**GOVERNMENT OF THE DISTRICT OF COLUMBIA
DEPARTMENT OF CONSUMER AND REGULATORY AFFAIRS
OFFICE OF THE ZONING ADMINISTRATOR**

Re: 200 K Street, N.W.

UNION PLACE PHASE II - PROPOSED DESIGN REVISIONS

A1.02a

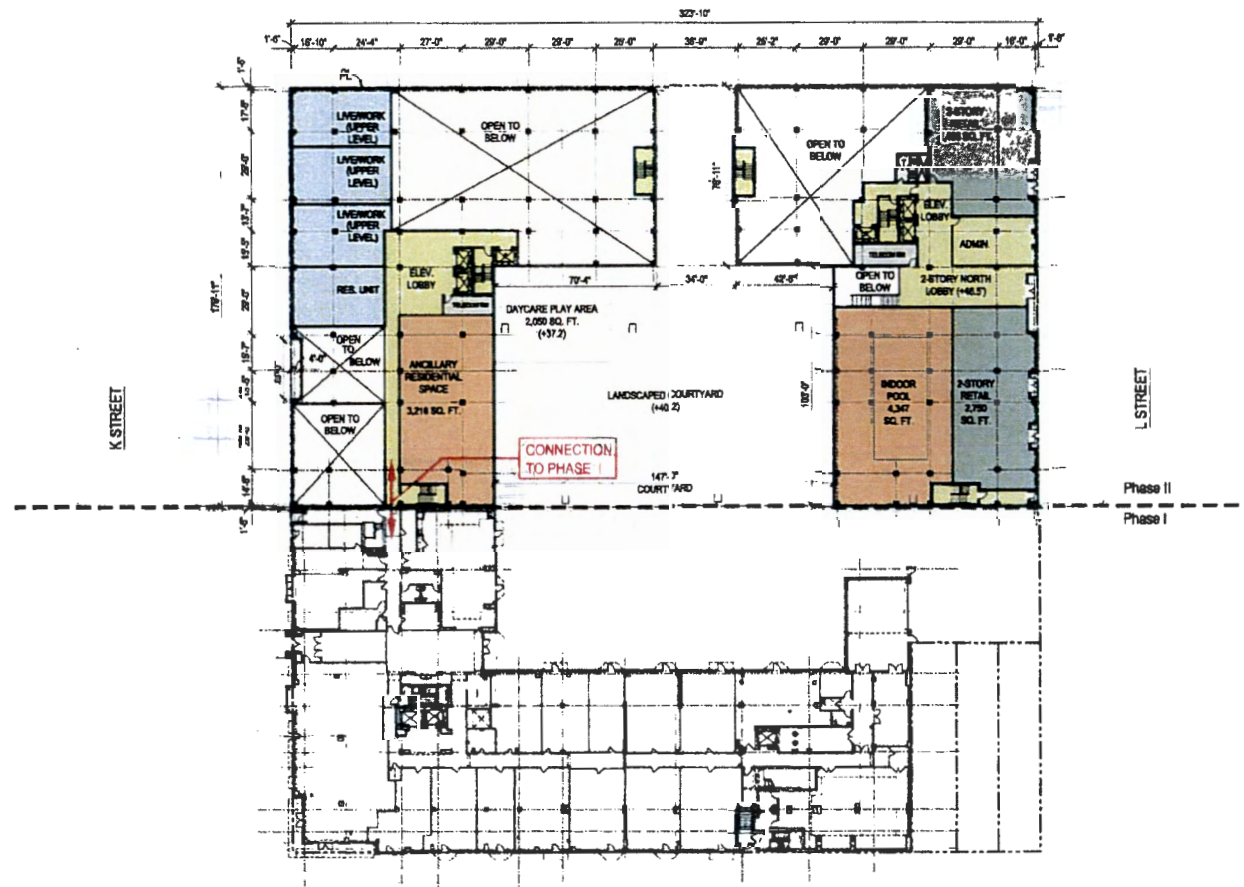
- The approved access to the parking garage for the 200 K Street building is shown on Sheet A1.02a as a ramp from 2nd Street. The approved location of the loading berth is also on 2nd Street immediately north of the parking garage entrance. The vehicular access area is comprised of two 25 foot curb cuts with a 6 foot safety island in the between. The proposed plan, shown on the First Floor Plan, dated December 5, 2012, would "flip" the location of the parking ramp and the loading berth, with the same total width of the access area. The exterior façade, which had the appearance of two separate garage doors, will look the same. This is consistent with the flexibility granted in Condition No. 1a of Order No. 05-36A, which allows the applicant to "vary the location and design of all interior components ... provided that the variations do not change the exterior configuration of the building."

- The approved first floor plan shows three live-work units at the southwest corner of the building and shows an indoor pool and related pool storage on the northeast corner of the building. The proposed first floor plan replaces the pool with additional residential units and replaces the live-work units with ancillary residential space, which will include lounges, meeting rooms, recreation rooms and other services for the residents. The approved second floor plan, Sheet A1.03a, shows the upper level of the pool area and the upper level of the live-work units. The proposed second floor plan inserts four units in place of the pool and three regular units in place of the three live-work units, where the open area above the pool existed and where the 2nd floor of the live-work units existed respectively, for a net increase of four units. The proposed third floor plan inserts four units in place of pool where the open upper level above the pool existed. These and other interior changes to the floor plans result in the total number of units proposed for the 200 K Street building ranging between 500 and 525 units, and increased the gross floor area of the building by approximately 7,304 square feet, as permitted by the flexibility granted in Condition No. 1e of Order No. 05-36A and for the increased FAR pursuant to Section 2409. The interior rearrangement is consistent with the flexibility granted in Condition No. 1a of Order No. 05-36A, cited above.

I conclude that all of the changes described above are minor modifications which are minimal deviations from the approved plans. All achieve the flexibility of design provided to the Zoning Administrator under the Regulations and specifically in the Commission's Orders. Accordingly, I conclude that construction as you have proposed above would be consistent with the overall PUD approval.

A1.03a

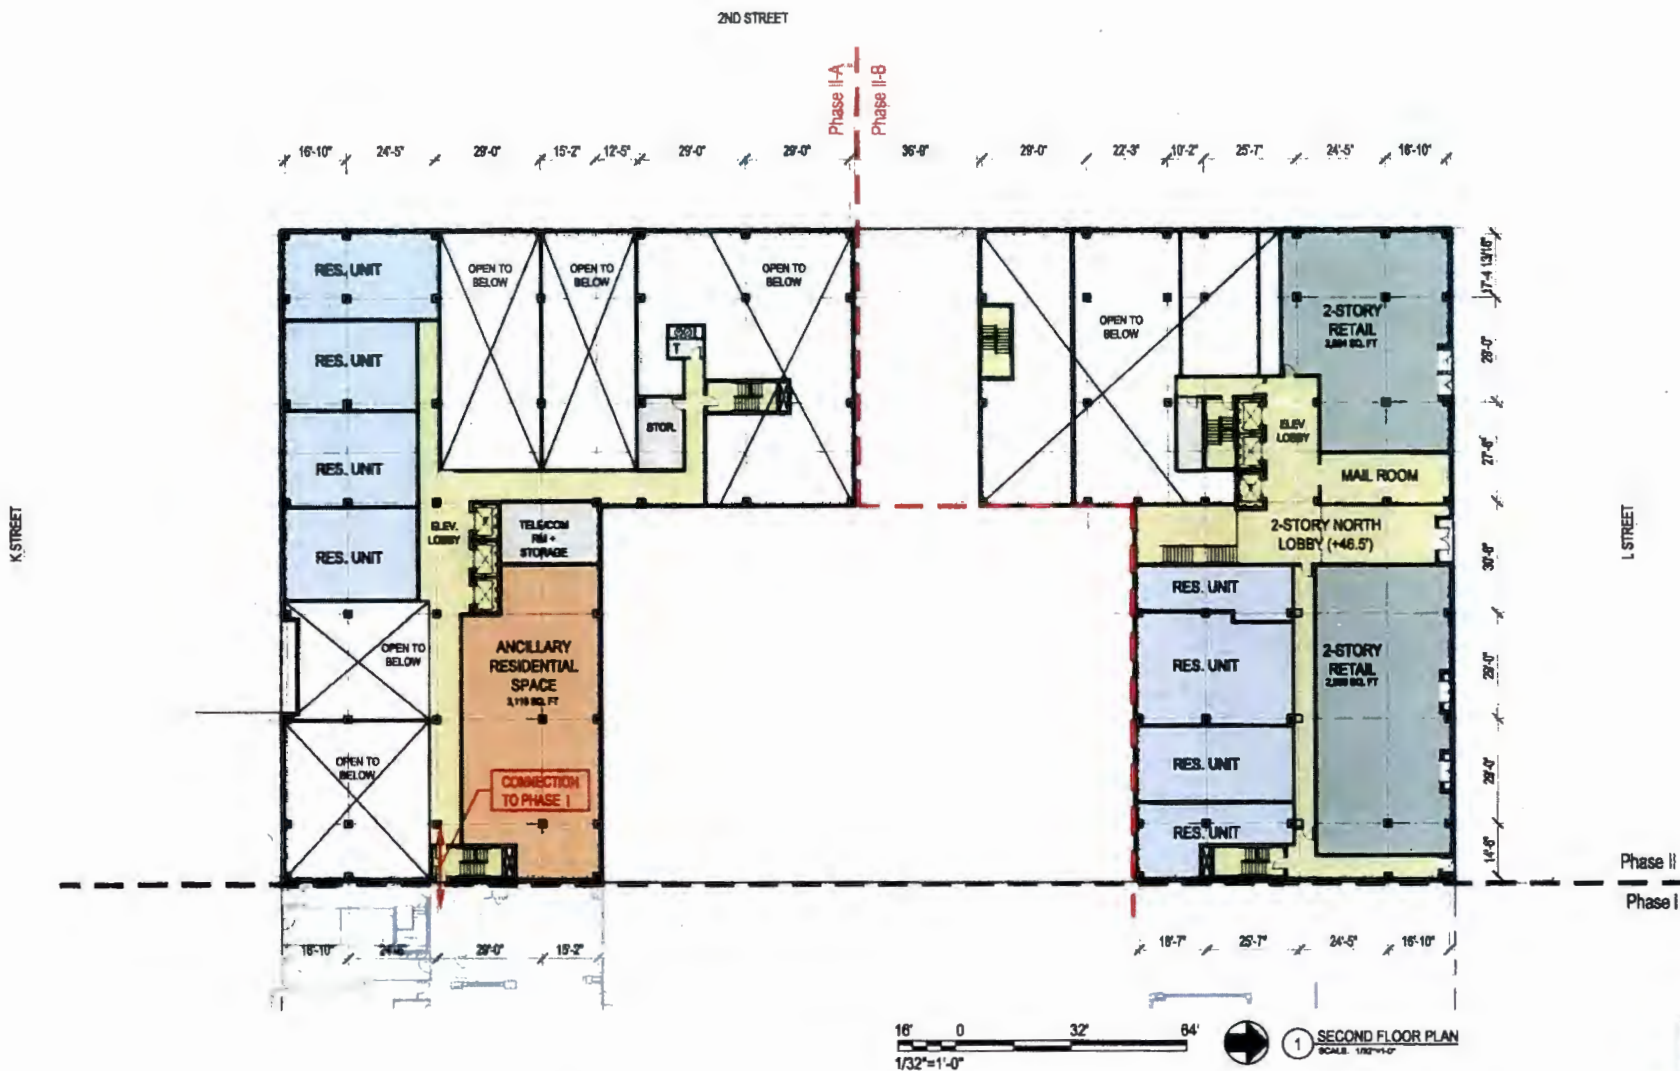
- The 200 K Street and 250 K Street buildings were connected through a common hallway and stairwell at the second, third and fourth floors, as shown on Sheets A1.03a, A1.04a and A1.05a. Under the proposed Second Floor Plan, dated December 5, 2012, there would be an interior connection only at the second floor level and arranged so that both buildings would have a corridor leading into a common stairwell. The interior rearrangement is consistent with the flexibility granted in Condition No. 1a of Order No. 05-36A, cited above.
